Date: Feb 23, 2001

From: George Penokie (Tivoli Systems)

Subject: Defining Targets/Initiators as Ports

The following show the changes in SAM-2 that would be required to change to support a port = target/initiator model.

Figure 8 — Target/Initiator hierarchy diagram

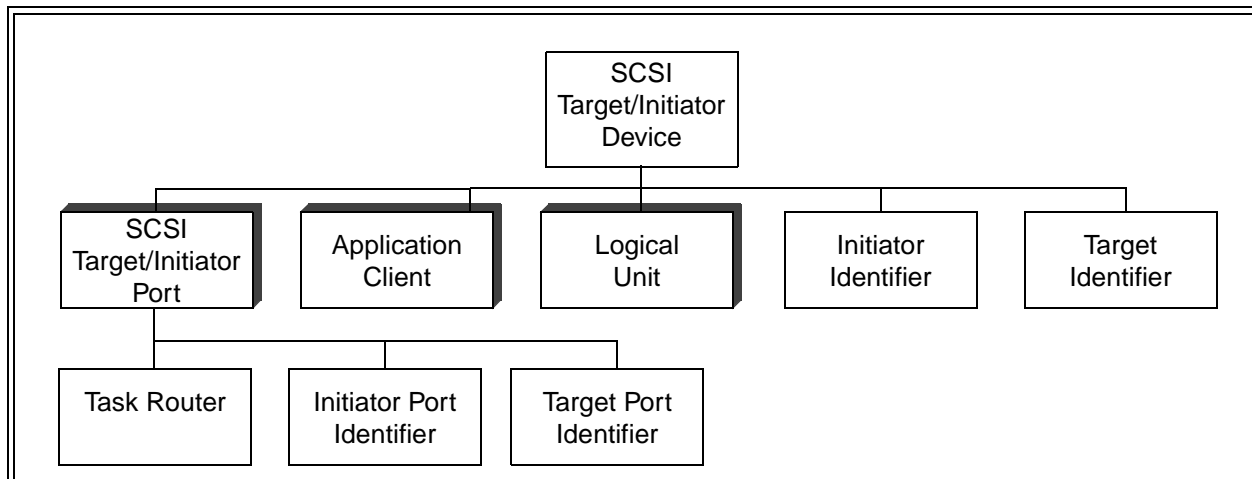
New SAM-2 section 4.7.3 SCSI target/initiator device

A SCSI target/initiator device (see figure 7) contains:

- a) one or more SCSI target/initiator ports each containing a task router, target port identifier, and an initiator port identifier;
- b) one or more logical units;
- c) zero or more application clients;
- d) target identifier; and
- e) initiator identifier.

Figure 10 — SCSI device functional models

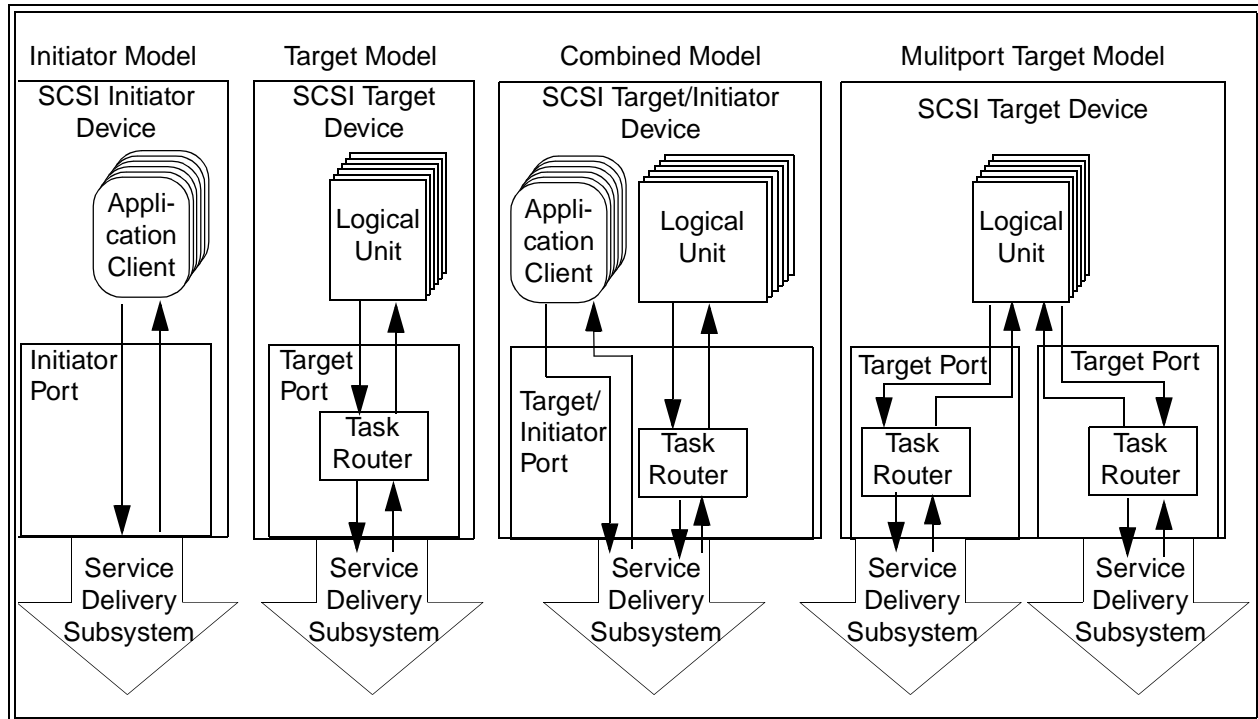
A SCSI device may contain only SCSI target ports, only SCSI initiator ports, only SCSI target/initiator ports or any combination of ports. Some of the port configurations possible for a SCSI device are shown in figure 10.

A target/initiator SCSI device is referred to by the role its port takes when it participates in an I/O operation. When a SCSI target/initiator device receives SCSI commands or task management functions, the SCSI target/initiator device takes on the characteristics of and is referred to as a SCSI target device. When a SCSI target/initiator device issues SCSI commands or task management functions, the SCSI target/initiator device takes on the characteristics of and is referred to as a SCSI initiator device.

Figure 11 — Multiple port target SCSI device structure model

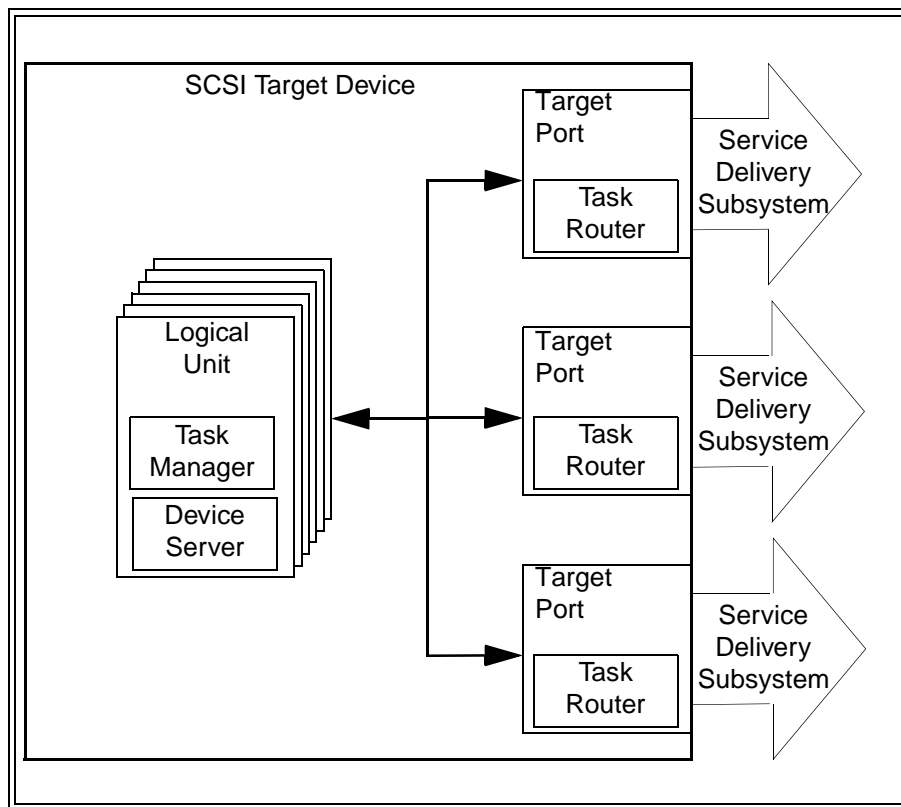
New SAM-2 section 4.11.2 Multiple port target SCSI device structure

Figure 11 shows the structure of a SCSI target device with multiple SCSI target ports. Each SCSI target port consists of a task router that is shared by a collection of logical units. Each logical unit contains a single task manager and a device server.

Two-way communications shall be possible between all logical units and all SCSI target ports, however, communications between any logical unit and any SCSI target port may occasionally be inactive. Two-way communications shall be available between each task manager and all task routers. Each SCSI target port shall accept commands addressed to LUN 0 and the task router shall route them to a device server for processing. The REPORT LUNS commands (see SPC-2) shall be accepted by logical unit 0 from any SCSI target port and shall return the logical unit inventory available via that SCSI target port. The availability of the same logical unit through multiple SCSI target ports is discovered by matching device identifier values in the INQUIRY command vital product data page (see SPC-2).

Figure 12 — Multiple port SCSI initiator device structure model

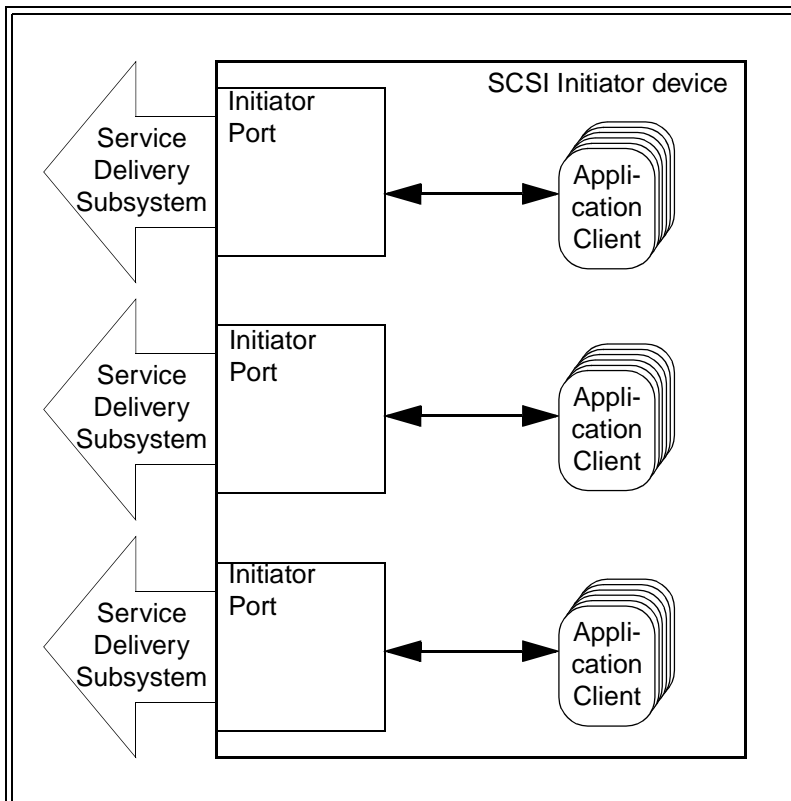
New SAM-2 section 4.11.3 Multiple port initiator SCSI device structure

Figure 11 shows the structure of a SCSI initiator device with multiple SCSI initiator ports. Each SCSI initiator port is shared by a collection of application clients.

Two-way communications shall be possible between an application client and its associated SCSI initiator port. Mechanisms by which a SCSI target device would have the ability to discover that it is communicating with multiple ports on a single SCSI initiator device are beyond the scope of any standards in the SCSI family of standards.

Figure 13 — Multiple port target/initiator SCSI device structure model

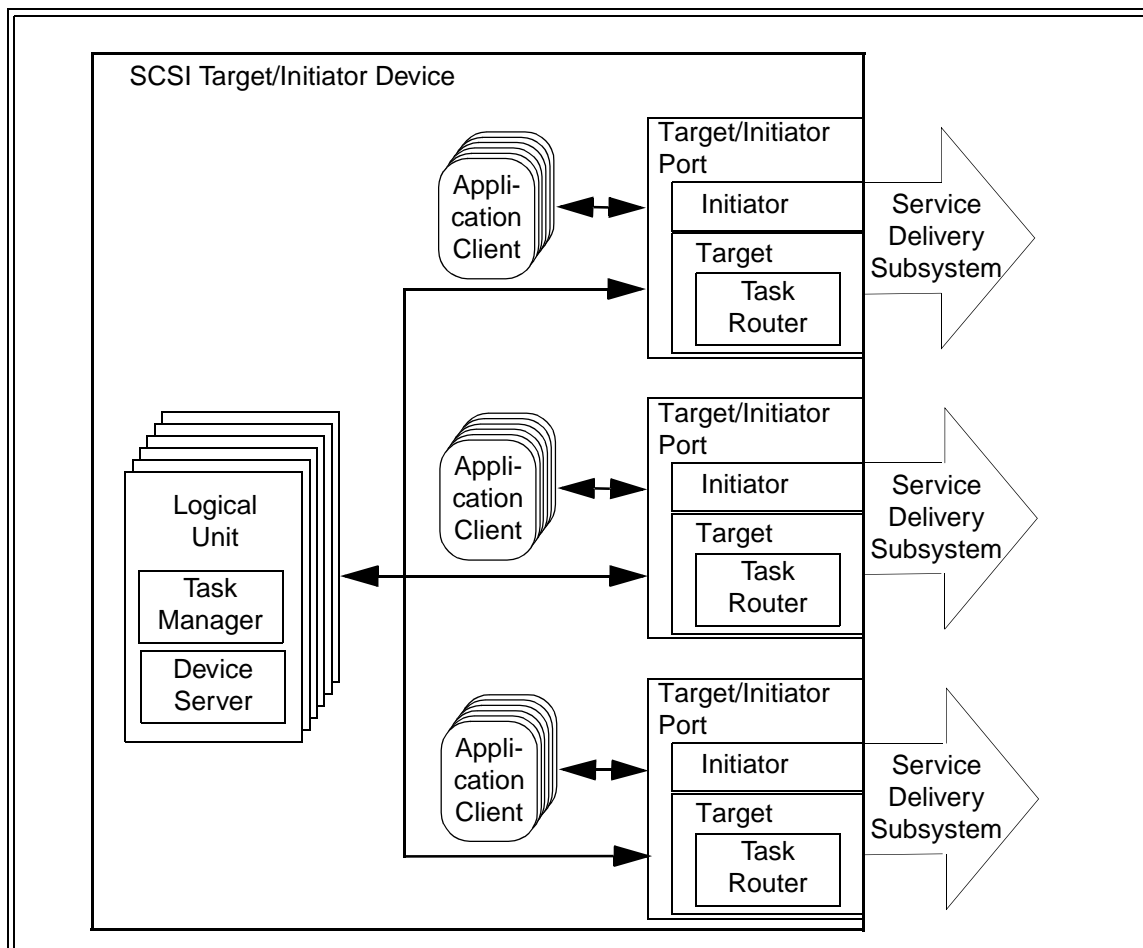
New SAM-2 section 4.11.4 Multiple port target/initiator SCSI device structure

Figure 11 shows the structure of a SCSI target/initiator device with multiple SCSI target/initiator ports. Each SCSI target/initiator port consists of a task router and is shared by a collection of logical units and application clients. Each logical unit contains a single task manager and a device server.

Two-way communications shall be possible between all logical units and all SCSI target/initiator ports, however, communications between any logical unit and any SCSI target/initiator port may occasionally be inactive. Two-way communications shall be possible between an application client and its associated SCSI target/initiator port. Each SCSI target/initiator port shall accept commands addressed to LUN 0 and the task router shall route them to a device server for processing. The REPORT LUNS commands (see SPC-2) shall be accepted by logical unit 0 from any SCSI target/initiator port and shall return the logical unit inventory available via that SCSI target/initiator port. The availability of the same logical unit through multiple SCSI target/initiator ports is discovered by matching device identifier values in the INQUIRY command vital product data page (see SPC-2).
